ADDENDUM NO. 1

July 20, 2026

This Addendum is hereby made a part of the Contract Documents and modifies and takes precedence over the original Contract Documents dated July 7, 2026.

LEBANON COUNTY MUNICIPAL BUILDING
PHASE II RENOVATIONS
22-036

1.14 A012 CODE PLAN – FIRST FLOOR

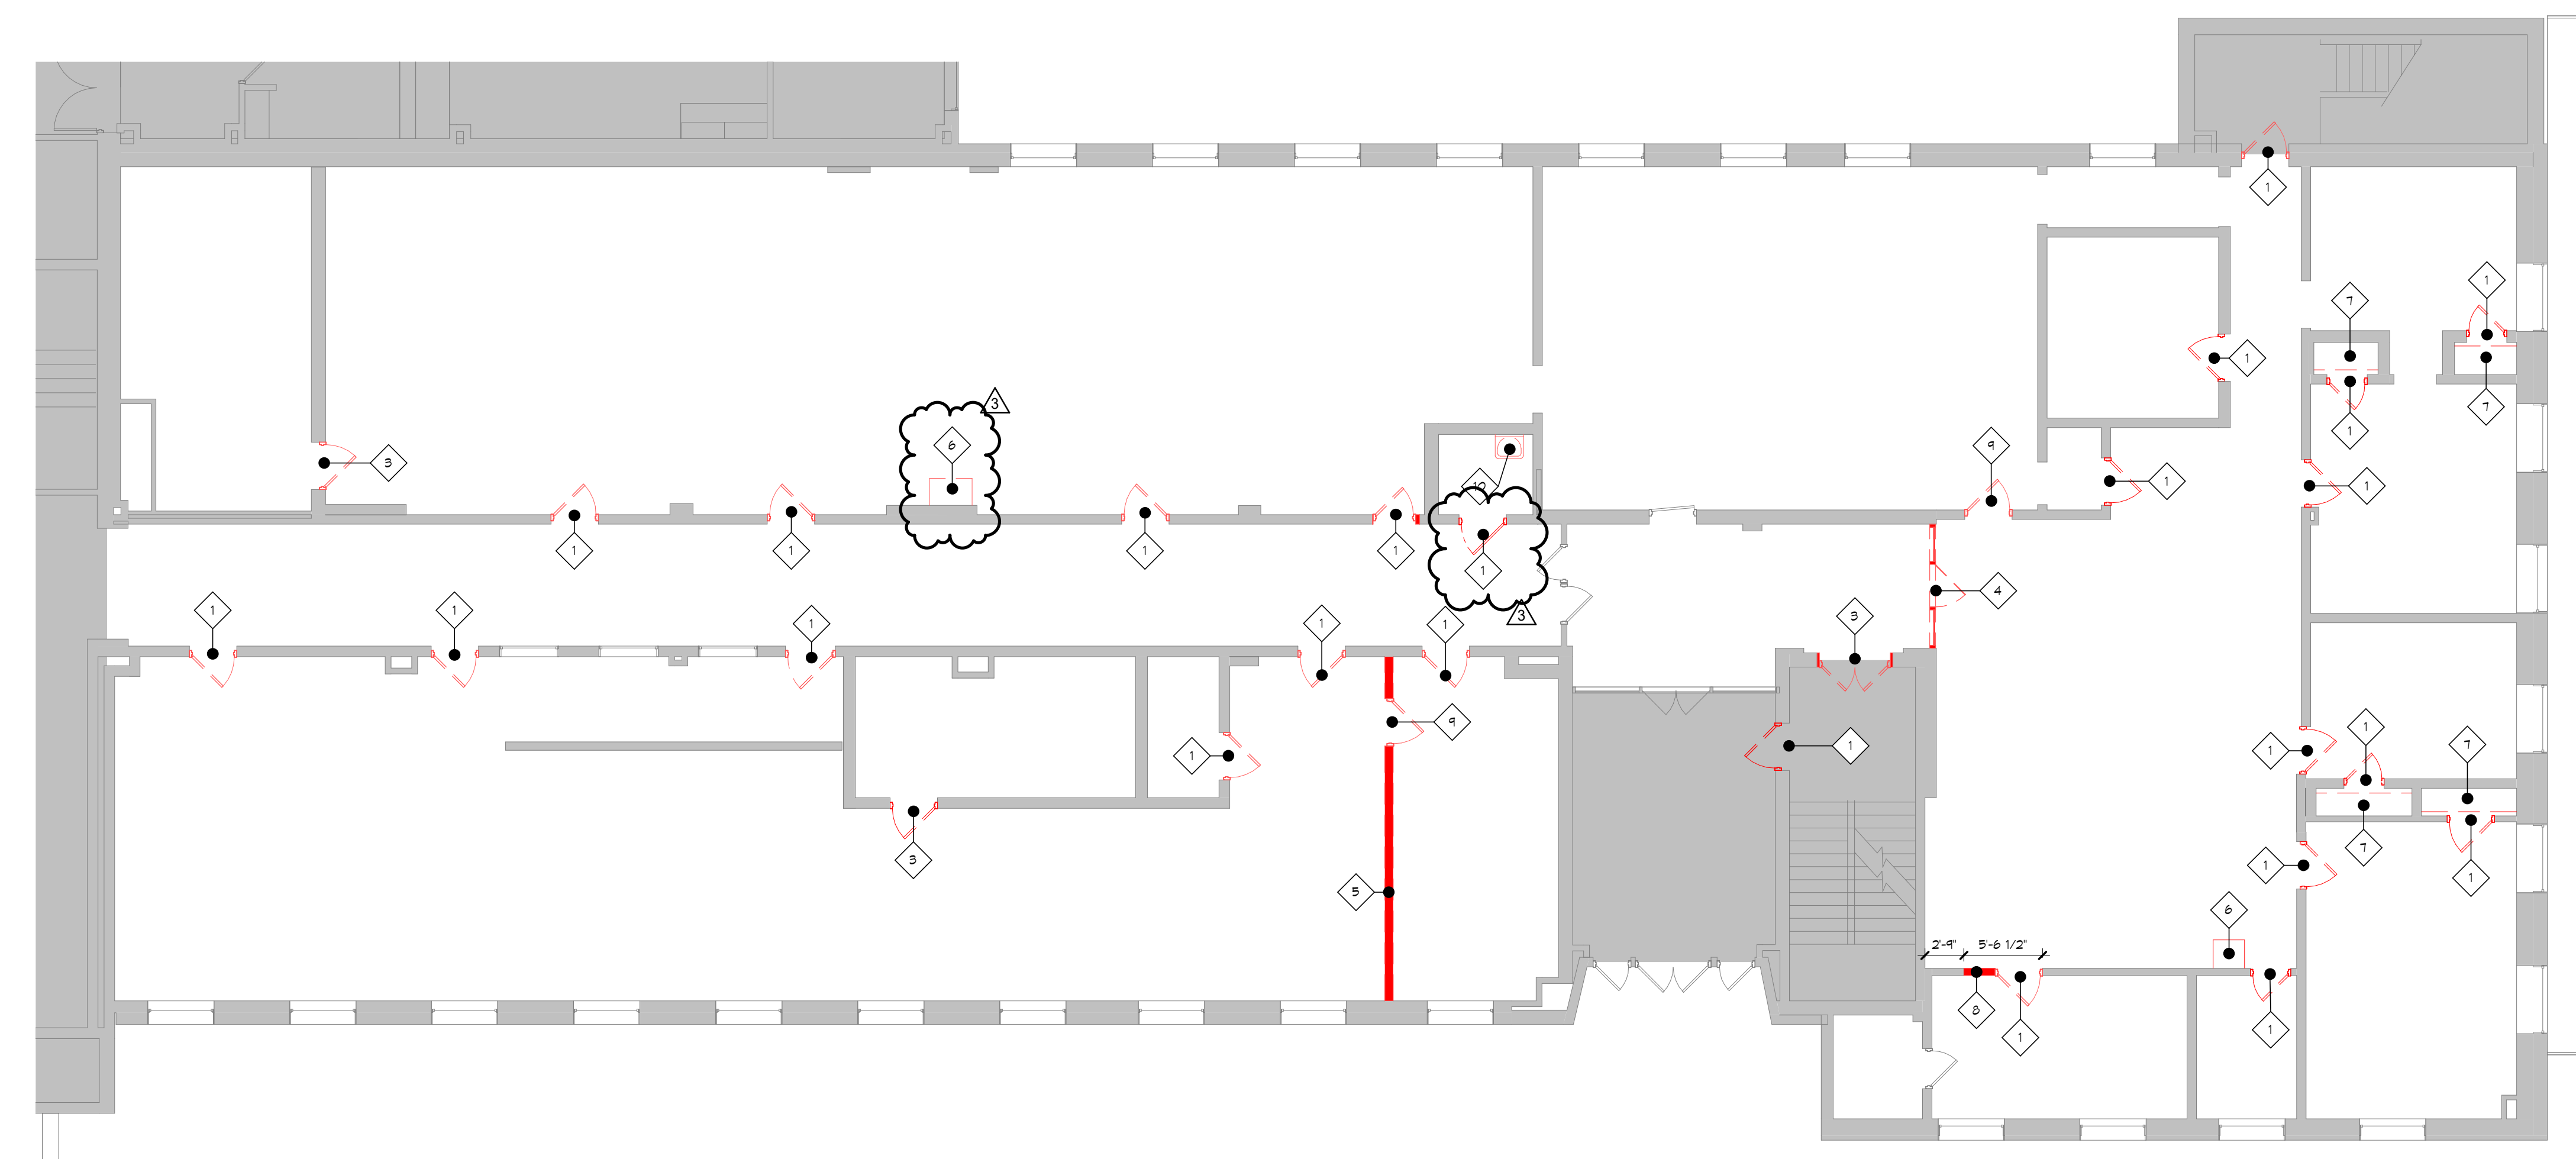
- a. REVISE Open Office Layout.
- b. RELOCATE Fire Extinguisher Cabinet.

1.15 A032 DEMOLITION PLAN

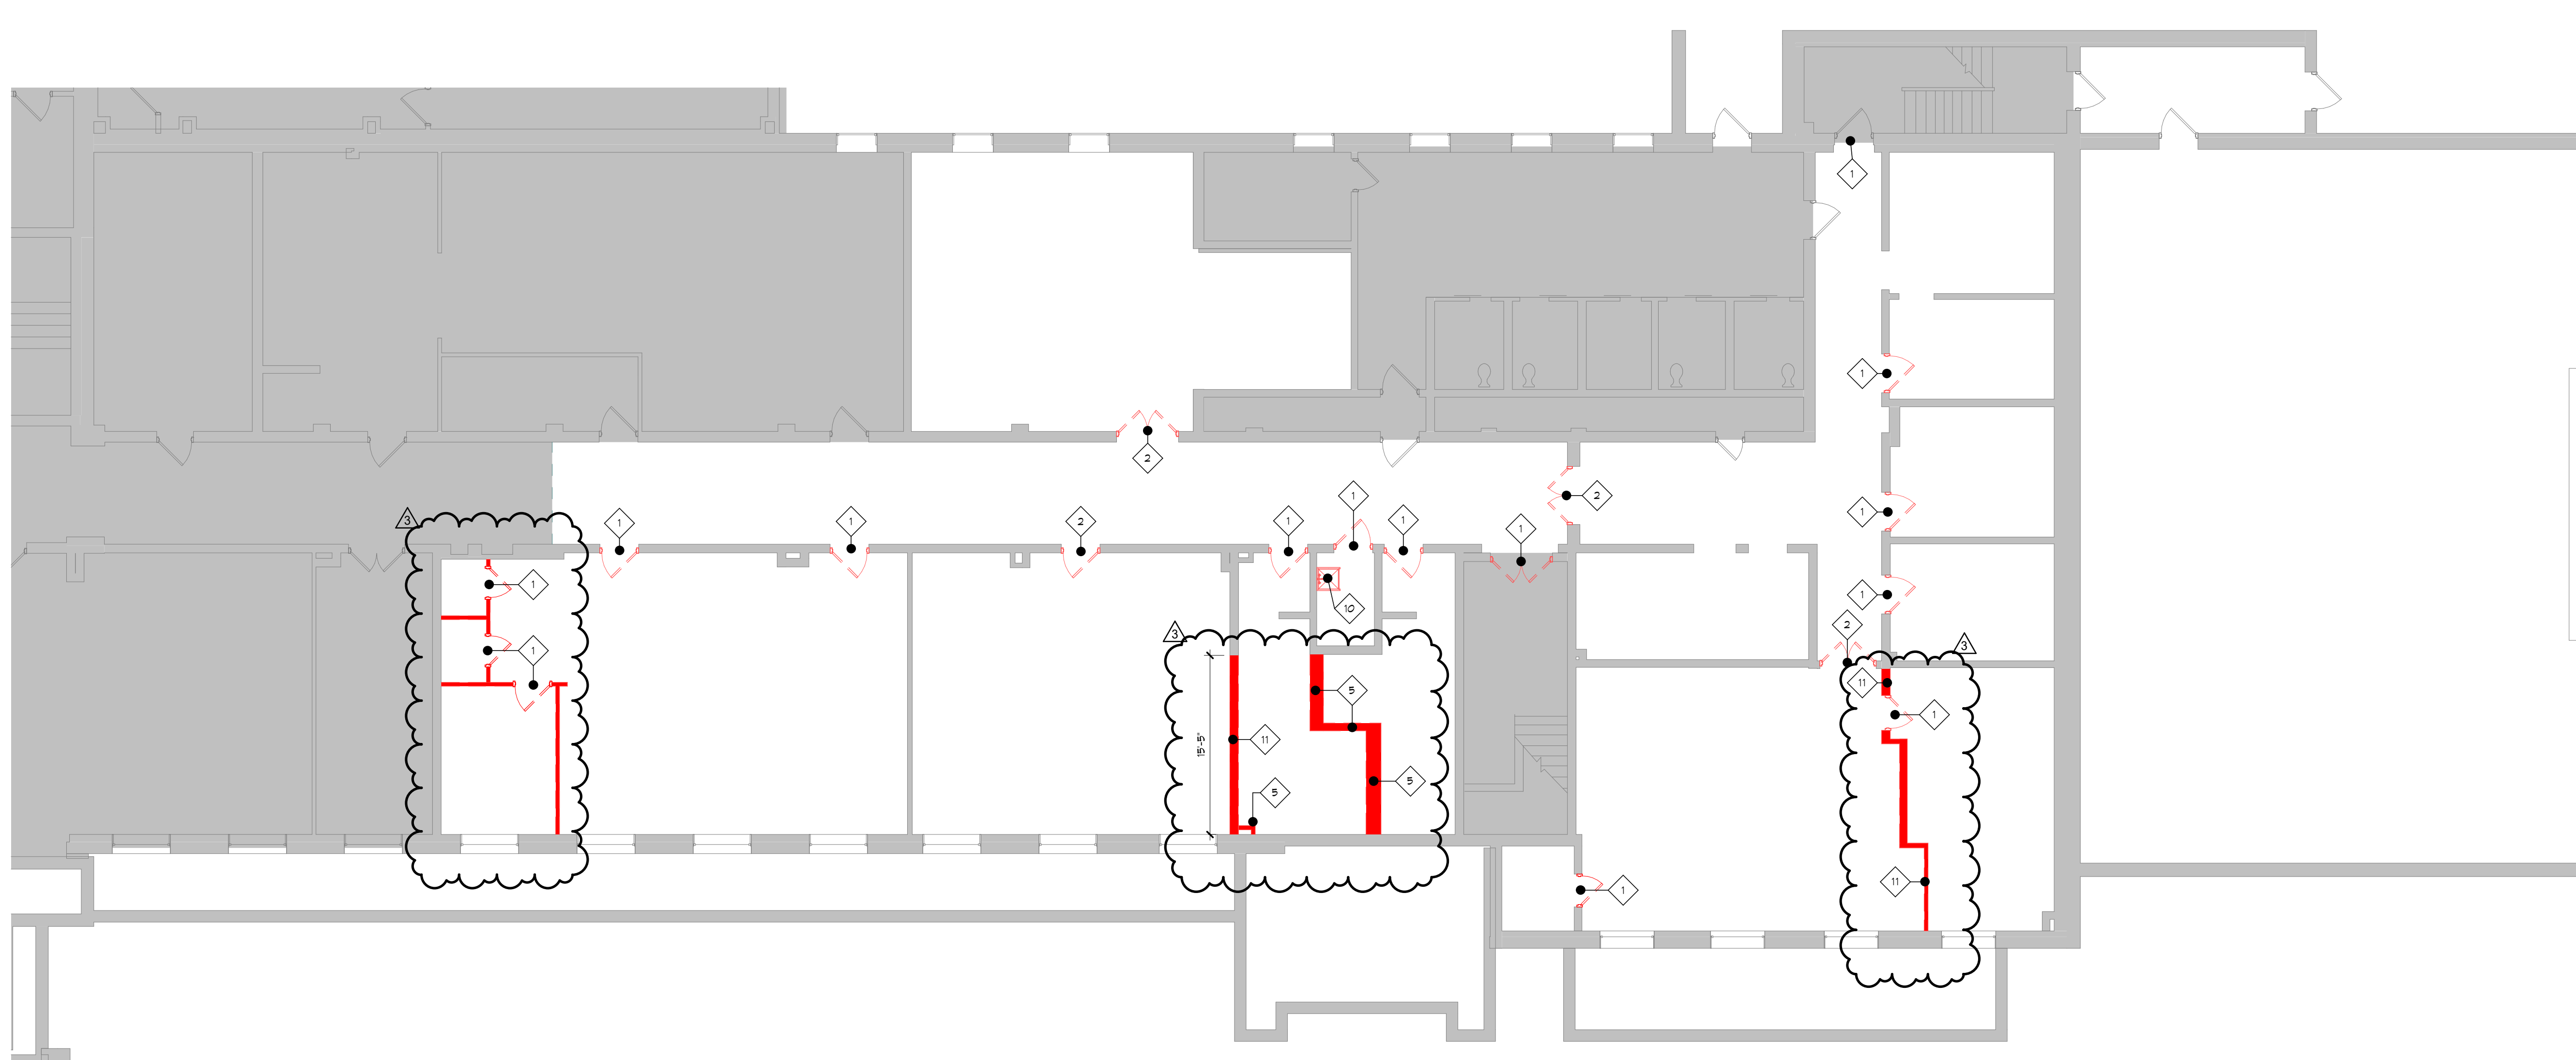
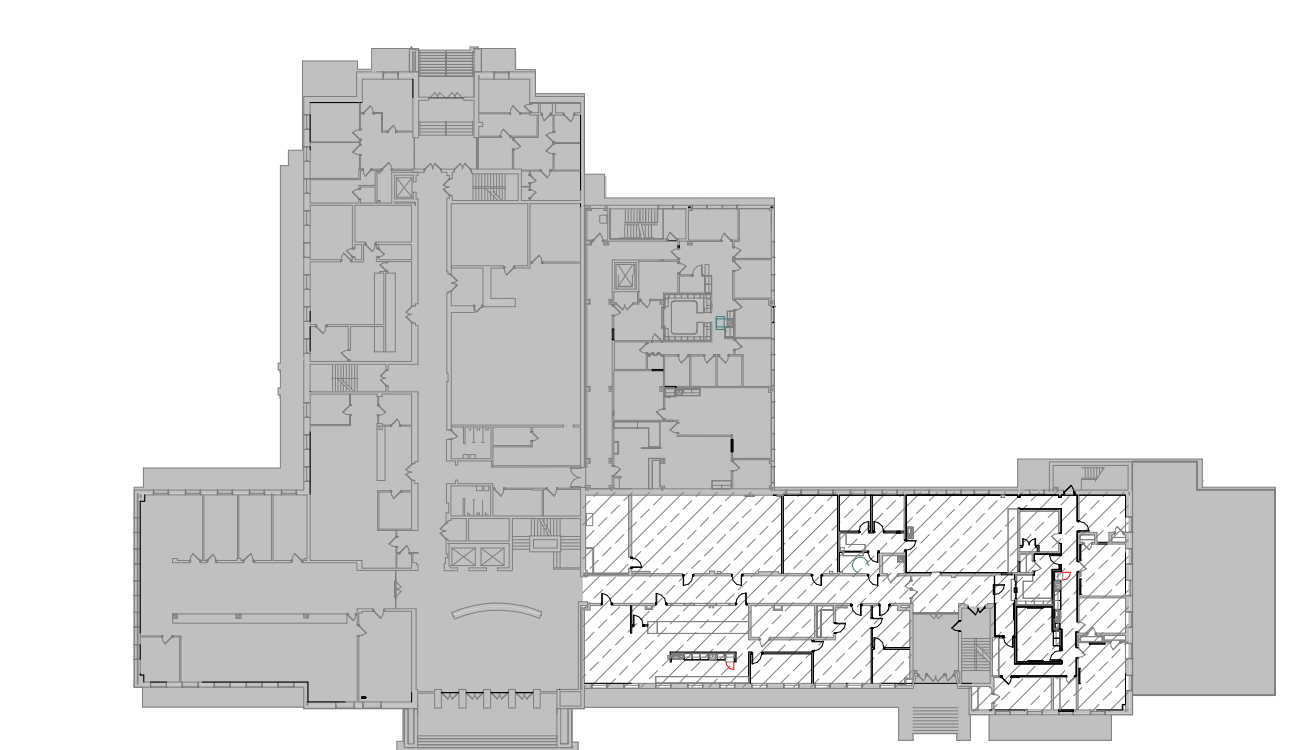
- a. REVISE Ground Floor and First Floor Demolition plans.
